**Northwestern Lehigh School District
6493 Rt. 309, New Tripoli PA 18066
CONSTRUCTION COMMITTEE MEETING
District Board Room
Friday, November 4, 2016, 9:00 AM**

2.01 High School Modernization Plan Review

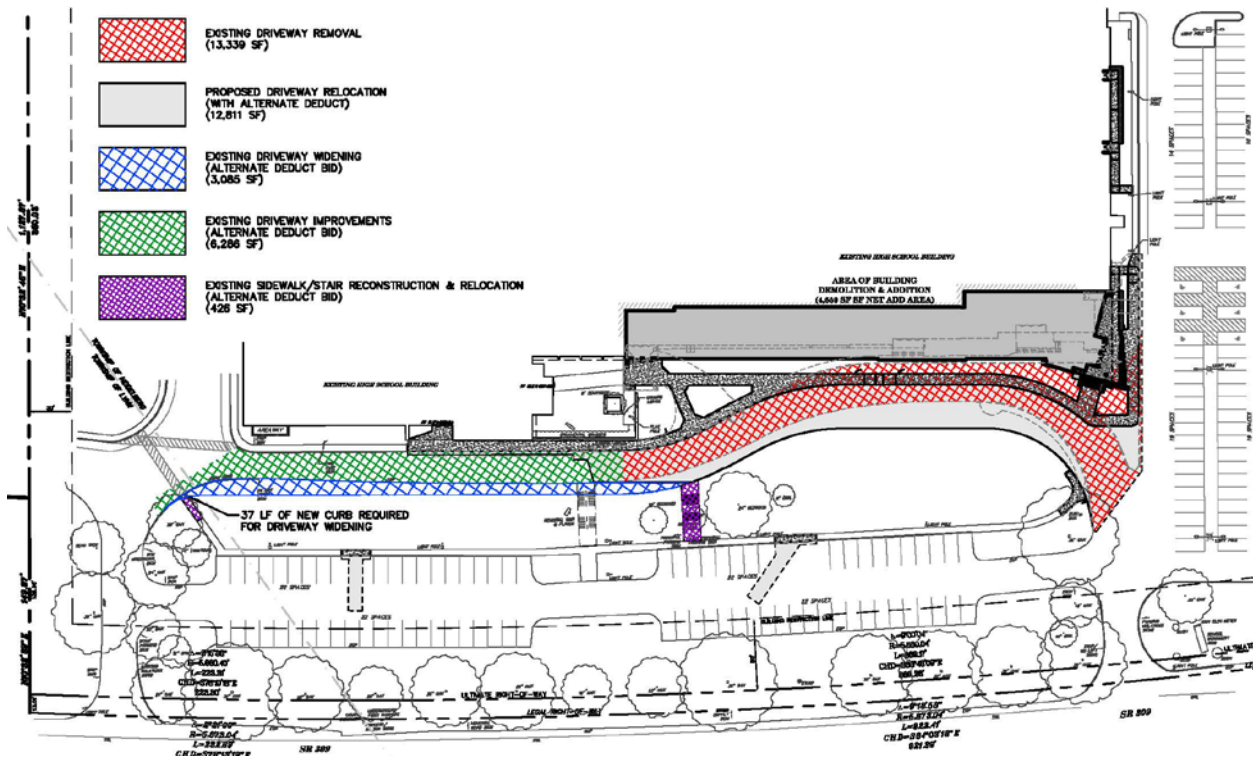
T. Degroot explained the proposed project consists of renovations and an addition to the existing Northwestern Lehigh High School. He reviewed the plan drawing of the driveway (on next page). He explained the Red is the existing removal, the Grey is the relocation, the Green is the alternate deduct and the blue is the portion to be widened. He stated in order to construct the addition, the driveway would need to be relocated to the south (toward RT 309) in order to provide room for the driveway plus an eight foot wide sidewalk for student loading and unloading. He said the current plan shows the bus drop-off driveway to be removed in its entirety. He mentioned there is a 24 foot wide recommendation but 30 feet would allow for a double stacking of buses and a by-pass lane. A. Oakes said this Red portion needs to be relocated as it would be touching the new addition to the building. T. Degroot added that there are old abandoned septic tanks buried next to the driveway which needs to be removed. P. Toll asked why they must be removed. T. Degroot explained they are unable to build on top of the tanks, since they are crumbling. He said they need to be removed and the area filled in.

T. Degroot explained the deduct alternate. He said the area of full depth paving will be reduced by 9,371 SF (noted in green and blue on the sketch) and the steps, western curb, western sidewalk will not need to be reconstructed. He stated the area highlighted in green is existing paving which would remain. He explained if the Deduct Alternate is taken it will reduce the limit of full depth paving; however, it would not reduce the need for the two detention/infiltration basins or the grading between the driveway and the parking lot along RT 309. He stated the sidewalk from the library entrance to the gymnasium entrance will still be constructed with the Deduct Alternate. He said the use of the deduct alternate would save about \$80,000. P. Toll stated the initial estimate was \$390K. He wanted to know what the additional cost would be. T. Degroot said the overall site cost estimate would be \$711K for the outside of the building. P. Toll wanted to know what the incremental cost was. A. Oakes explained there is a \$300K restoration cost already built into the budget. B. Brandis said this fund source is to grade and repair the outside. Dr. Wright said the project was budgeted for \$390K plus the \$300K restoration cost, so the cost difference is really between the \$690K and \$711K. She stated it is about a \$20K incremental cost.

P. Toll asked if the driveway could be brought down as a straight line instead of the curve. He said the District would lose about eight feet but two buses can fit. T. Degroot said yes but the tanks would still need to be removed and the area graded.

W. Dellicker asked if the pavement is below grade by the added retaining wall. T. Degroot said it is about three to four feet lower than the parking lot and draining and railing would be installed.

W. Dellicker asked what the boxes were in the Red area. T. Degroot said handicapped parking and ramps to pavement with a six inch elevation.
